Item No. 3 Zoning Agreement Amendment - 5 Scurfield Boulevard (River Heights-Fort Garry Ward) File ZAA 16/2008

RE: **Zoning Agreement Amendment - 5 Scurfield Boulevard**
File ZAA 16/2008 [c/r DAV 131179/2008D]

DATE:	September 11, 2008
FILE:	**ZAA 16/08**
RELATED FILES:	DAV 08-131179/D, DASZ 44/79
SUBJECT:	To amend the Zoning Agreement affecting the land shown outlined below by deleting the width requirement stated in Clause 5 and replacing it with "1.2 metres (four feet)".
LOCATION:	**5 Scurfield Boulevard, at Waverley Street**
LEGAL DESCRIPTION:	LOT 6 BLOCK 7 PLAN 15345 16/23 ST V OTM
APPLICANT:	Frieder Aldinger, MMM Group Limited 93 LOMBARD AVE SUITE 111 WINNIPEG MB R3B 3B1
OWNER:	2253062 MANITOBA LIMITED C/O MMI COMMERCIAL REAL ESTATE LTD ATTN: LINDSEY SAUNDERS 430 DOVERCOURT DR UNIT A WINNIPEG MB, R3Y 1N4
RECOMMENDATION:	***Not* Proceed With.**

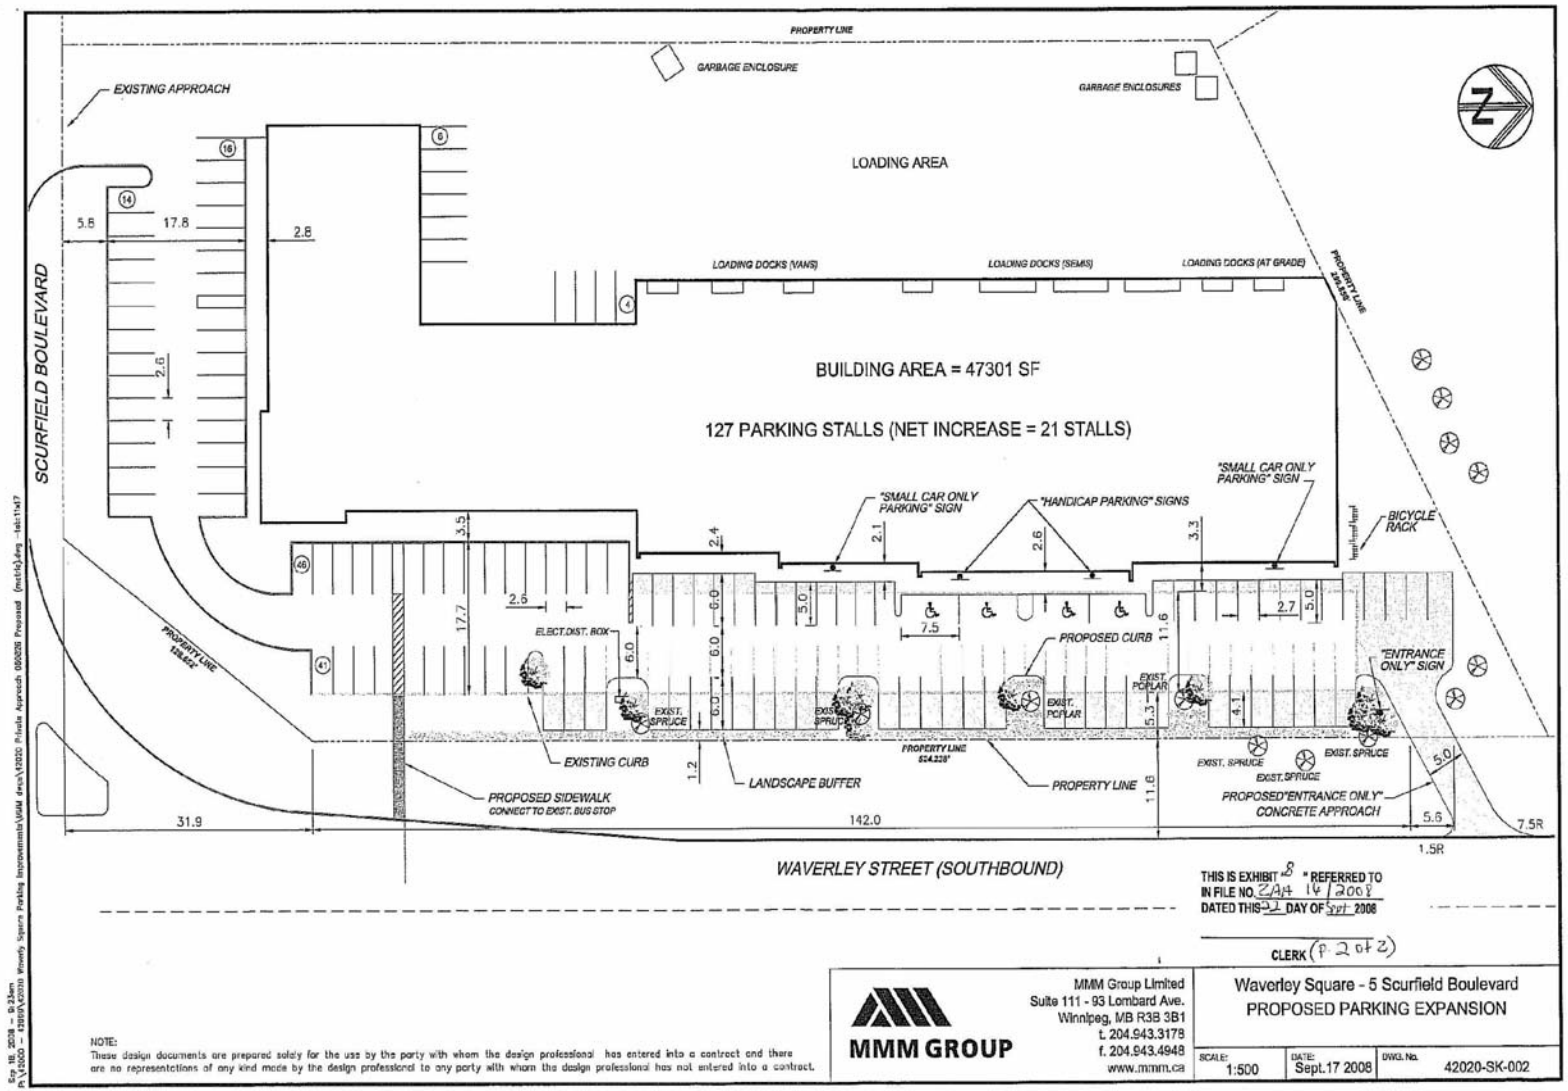
The proposed location for the bicycle parking, illustrated in Sheet 2 of 2 of a site plan submitted in connection with the aforementioned File DAV 08-131179/D, is not visible from any main entrance to the units at 5 Scurfield Boulevard or to windows in the building on the subject land. In order to provide a sense of security, personal safety and convenience, the bicycle parking should be clearly visible to people in the building on the subject land and the main entrances should be clearly visible to people at the bicycle parking area(s).

While it is recognized that the preservation of several mature trees would mitigate, to some degree, the proposed east yard depth of only four feet it is noted that 31 parking spaces would be adjacent to the east yard, showing that most of the east yard would be four feet deep.

2. That bicycle parking be provided in accordance with Section 169 of The Winnipeg Zoning By-law No. 200/2006 and located such that it is clearly visible to people in the building on the subject land and the main entrances to the east side of the building are clearly visible to people at the bicycle parking area(s).

3. That a pedestrian connection to/from the building on the subject land and a Winnipeg Transit but stop be provided in substantial conformity with site plan filed as Exhibit 17 for File ZAA 16/2008.
